## *Department of Planning, Preservation & Sustainability*

### **Corinne Street PUD Garage Door Guidelines**

**Carriage House Door**  
COMPANY

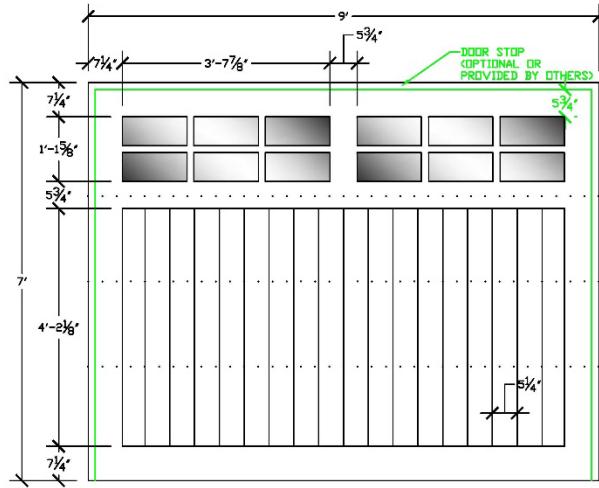
The BAR-Large in considering an After-the-Fact approval (September 25, 2024) for a garage door in the PUD made a motion that “replacement door can be metal but needs to more closely match the aesthetic of the original door (lite cut, profile, depth, and color)”. The BAR-Large gave additional direction at the October 23, 2024 with staff showing the specifications of example doors.\* The Board viewed and approved these doors or equivalent as acceptable replacements.

Character defining features of existing garage doors that are required for replacement (the image provided below has all of these character defining features):

- Two sets of 3 over 3 lites
- Framed border
- Vertical board pattern
- Clear glazing
- Uniform color
- Color match to existing
- Any material is potentially approvable as long as it meets code and is an authentic use of materials (e.g. decorative faux wood grain in a metal door is not authentic and therefore not approvable).

Per this decision of the BAR-L, Staff can approve proposed garage doors for the Corinne St HOA/PUD that follow the design and character defining features of the existing approved garage doors. Garage doors should be approved by the BAR and the Building Department, made of flood damage resistant materials that meet current Building Code and follow the intent of the FEMA guidelines as set forth by the Chief Building Official.

\*This is one of three door illustrations reviewed and approved by the Board of Architectural Review-Large on October 23, 2024 as a possible replacement door. This is an example of what could be approved by Staff based on the Board motion. The renderings were provided by the *Overhead Door Company of Charleston* of specification for a Carriage House Door Company garage door. Devin McComsey of *Overhead Door Company of Charleston*; [dmccomsey@ohdocs.com](mailto:dmccomsey@ohdocs.com).
